**REPORT TO GEORGES RIVER COUNCIL
LPP MEETING OF THURSDAY, 13 DECEMBER 2018**

LPP Report No	LPP064-18	Development Application No	DA2018/0217
Site Address & Ward Locality	1-5 James Street Blakehurst Blakehurst Ward		
Proposed Development	Lot consolidation, demolition of all buildings, construction of a part 4 part/5 storey residential flat building containing twenty three units, basement parking, service provision, drainage and landscaping works		
Owners	PD Roberts, GC Evans, J and D Hatzikalimnos		
Applicant	Antoine Saouma		
Planner/Architect	Planner – Think Planning; Architect – Antoine Saouma		
Date Of Lodgement	1/06/2018		
Submissions	No submissions received		
Cost of Works	\$6,950,000		
Local Planning Panel Criteria	Development to which State Environmental Planning Policy No 65 – Design Quality of Residential Apartment Development applies		
List of all relevant s.4.15 matters (formerly s79C(1)(a))	Kogarah Local Environmental Plan 2012; Kogarah Development Control Plan 2013 State Environmental Planning Policy No 65 – Residential Apartment Development; SEPP 55 – Remediation of Land; SEPP (Vegetation in Non-Rural Areas) 2017; SEPP (BASIX) 2004; Greater Metropolitan Regional Envir

North west elevation, showing location of height non-compliances.
Source: Applicant’s DA plans, marked up.

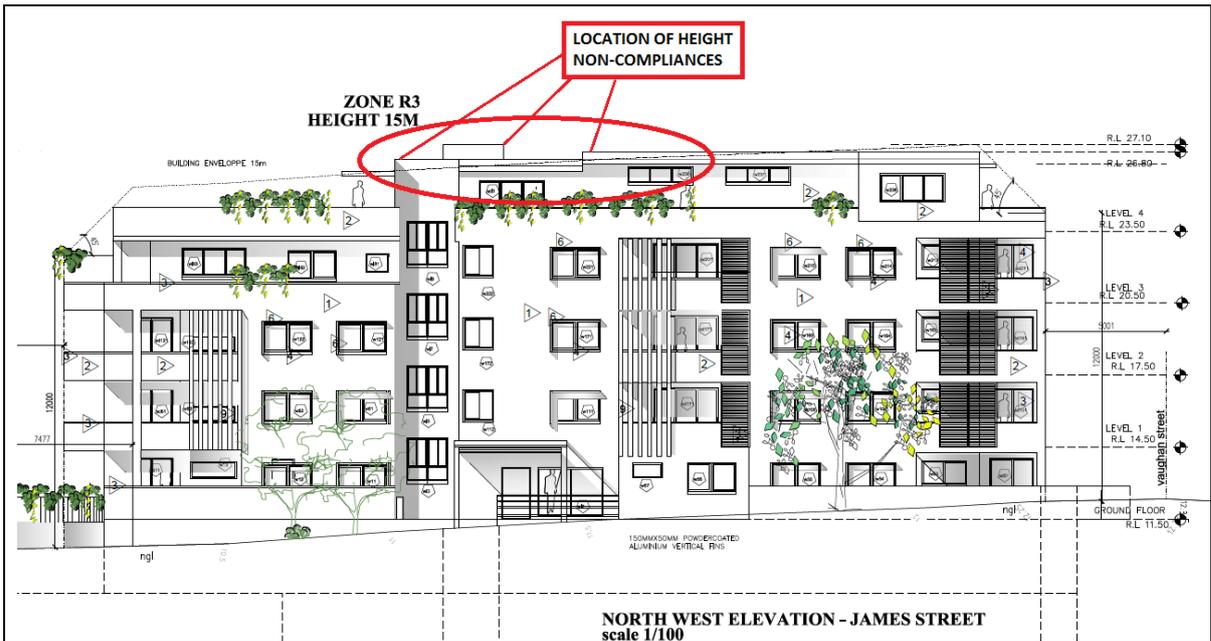
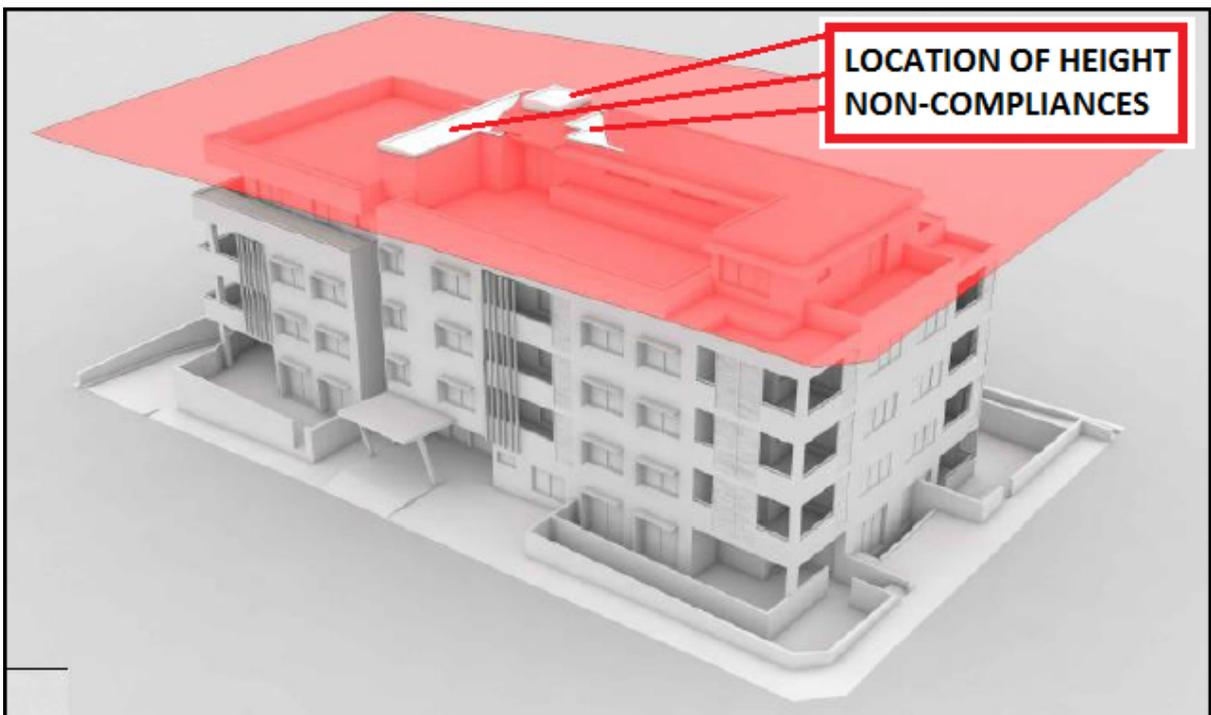
- 27. The Height of Buildings Map (Map No 7) under Kogarah LEP 2012 prescribes a maximum building height of 15m.
- 28. The development proposes a height of 15.58m (measured at the lift over-run) and 15.2m (measured at the top of the uppermost parapet), which does not comply with the 15m height control of the Kogarah LEP 2012. The extent of the non-compliance, at the highest point being the top of the lift over-run, is 580mm (0.58m) or 3.86% above the 15m height limit.
- 29. The location and extent of the non-compliance is illustrated in the following drawings (north west elevation and the building height blanket drawing):

Comment: The applicant's justification is supported. As shown on the building height blanket drawing (above), most of the non-compliant portion is located towards the centre of the building and is set well back from the edges of the built form, and as such it will not be visible or discernible when viewed from street level.

Communal Open Space – Pre-DA Lodgment Plans
Source: Applicant’s Pre-Lodgment Plans, marked up

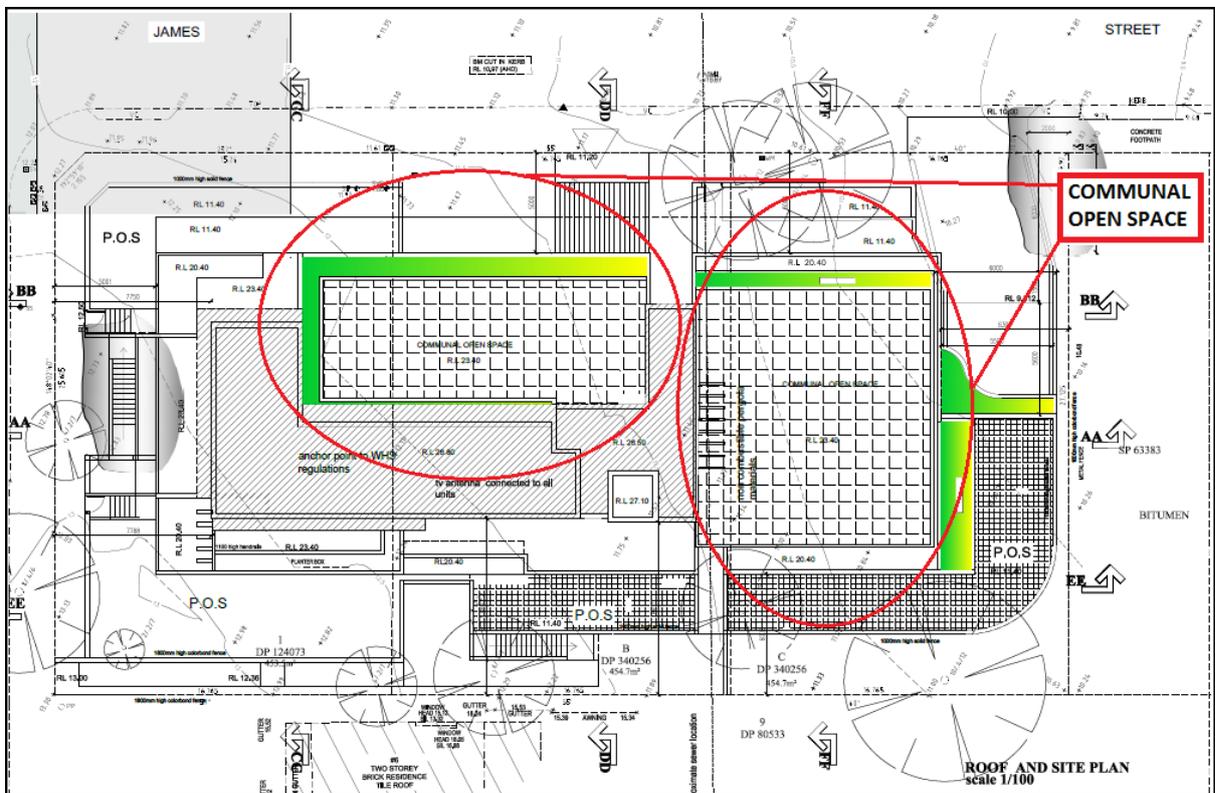
89. Panel's comment: *Care must be taken to protect trees growing on adjacent properties which have Tree Protection Zones extending on to the subject site. The applicant*

93. *The applicant should attempt to provide deep soil along the boundary with the car park and ensure medium/large canopy tree planting (for environmental, microclimate and screening purposes).*

76. The rooftop communal open space has been significantly increased, as indicated in the following diagrams which show how the communal open space has been increased from the pre-lodgment to the DA plans.

85. Assessing Officer's comment: As shown previously, the rooftop communal open space has been provided with perimeter planter boxes to improve amenity, as recommended by the Design Review Panel.

Floor plan of levels 1-2 showing the general position of units that do not receive direct sunlight

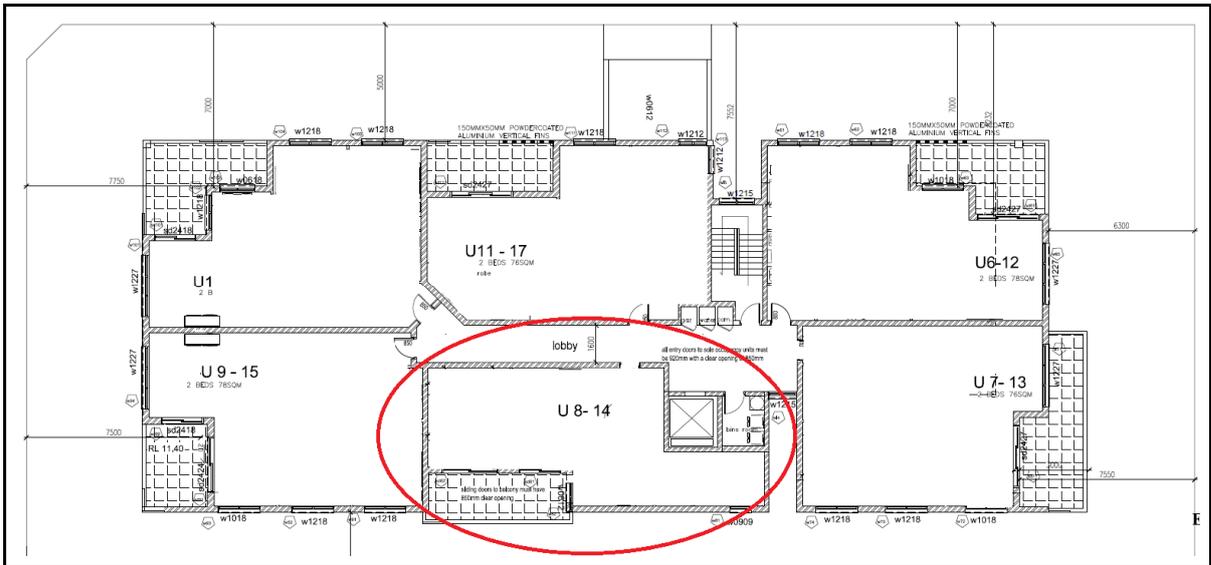
134. The ADG recommends that a maximum of 15% of units receive no direct sunlight between 9am and 3pm mid winter.
135. The development proposes 4 of the 23 units (units 3, 8, 14, 19) (ie 17%) which receive no direct sunlight between 9am and 3pm mid winter, which does not comply with the ADG criterion.
136. The location of these units is generally on the southern side of the central lobby and it is not possible to provide the required amount of direct sunlight to these units. The position of these units within the floor plan is consistent with the plan below.

Height and Building Envelope controls in Kogarah DCP 2013

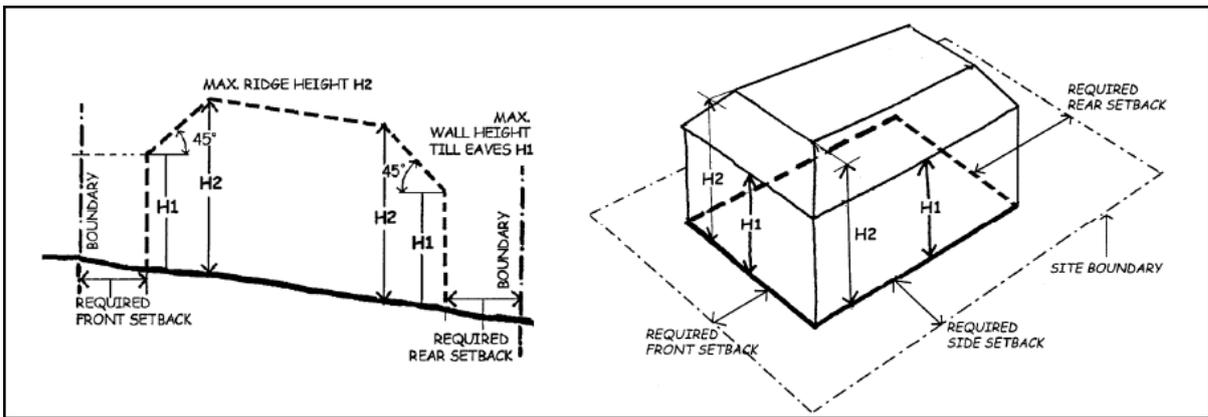
141. Kogarah DCP 2013 contains height and building envelope controls for residential flat building developments. These state that a 4 storey residential flat buildings are to have a “H1” height control of 12m; and a “H2” height control of 14m, where the “H2” height control is at a 45° angle from the H1 control. This is explained in the following diagrams.

- The non-compliance has resulted from the recent (May 2017) gazettal of the “New City Plan” as an amendment to Kogarah LEP 2012, which prescribed a new 15m height control for the subject land under the Kogarah LEP 2012.

- The height controls in KDCP 2013 are inconsistent with those in the LEP. In the hierarchy of planning controls, LEP provisions take precedence over those in the DCP.

- The development is consistent with the intended outcome as per the recently gazetted New City Plan, which is to increase building heights and densities in the Kogarah area.
